UNITED STATES PATENT AND TRADEMARK OFFICE

APPLICATION NO.	FILING DATE	FIRST NAMED INVENTOR	ATTORNEY DOCKET NO.	CONFIRMATION NO.
10/785,065	02/25/2004	Nicholas J. Berg	2241.0010000/TGD/JDS	8925

Office Action Summary

DETAILED ACTION

Fig. 1

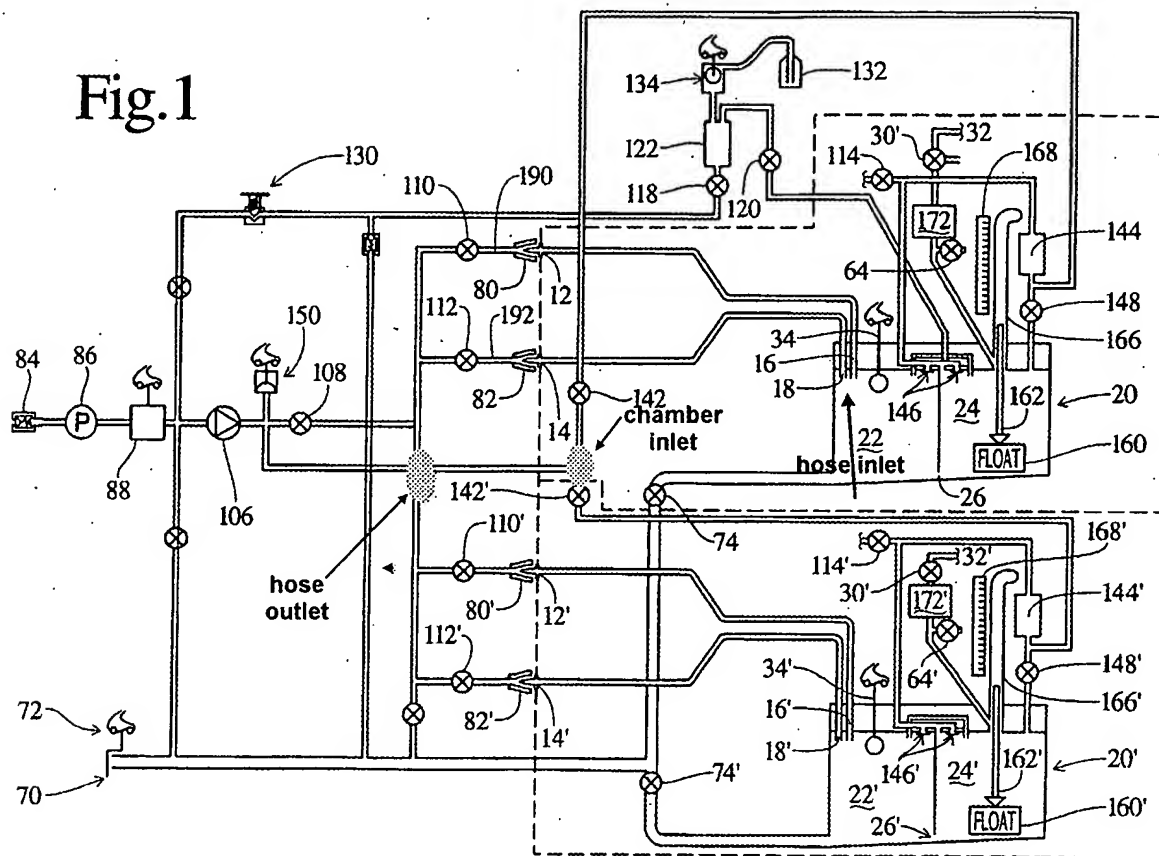
4. Claims 1-4 and 6-13 are rejected under 35 U.S.C. 102(b) as being anticipated by Bradbury et al. (US 5,741,238). Regarding claim 1 Bradbury et al. discloses vessel 20 for collecting, transferring, and disposing of medical and biological fluid wastes while minimize the human interaction and possible exposure to contaminated surfaces (abstract, lines 1-3, col. 1, ll. 54-63), comprising:

A tube/ waste material transfer hose 16 having an inlet/first chamber 22 and an outlet for transferring waste material (col. 3, ll. 46-53, figure 1);

A waste material collection chamber 24 having an inlet in communication with the outlet of the transfer hose 16 and an outlet adjacent drain hose 70 (col. 3, ll. 50-54, figure 1);

A vacuum connected to collection chamber 34 by a vacuum line 32 (col. 3, ll. 63-67); and

A disinfectant/cleaning fluid chamber 122 for holding a sufficient volume of disinfectant, said fluid chamber 122 communicating and receiving an inlet of the transfer hose 16 (col. 5, ll. 57-62, figure 1).

Regarding claims 2 and 4 Bradbury et al. discloses a float switch 24 which senses the level of the fluid in the vessel 20 as the fluid level within the chambers rises and sends a signal to an electronic control circuitry/switch 40 that terminates suction when the vessel 20 is filled to capacity (col. 3, line 64-col. 4, line 14).

Regarding claim 3 Bradbury et al. discloses a drain hose/disposal pump connected to collection chamber/vessel 20 by outlet 70 to move waste material out of the collection chamber 20.

Regarding claim 6 Bradbury et al. discloses drain valve/filter 74 disposed within vacuum line 32 between the vacuum source and float switch 24 that allows residual

liquids to drain fully after pumping of disinfectant fluid has stopped (col. 6, ll. 30-34, figure 1).

Regarding claims 7-8 Bradbury et al. discloses cleaning fluid chamber 122 is positioned upstream/upward from the inlet of the transfer hose 16 and the waste collection chamber/vessel 20 and therefore permitting cleaning fluid to be drawn into the transfer hose and disposed of by the apparatus (figure 1, col. 5, ll. 45-50).

Regarding claim 9 Bradbury et al. discloses valve/suction nozzle 30 connected to a pathway along the inlet of the hose 16 (col. 3, ll. 63-64, figure 1).
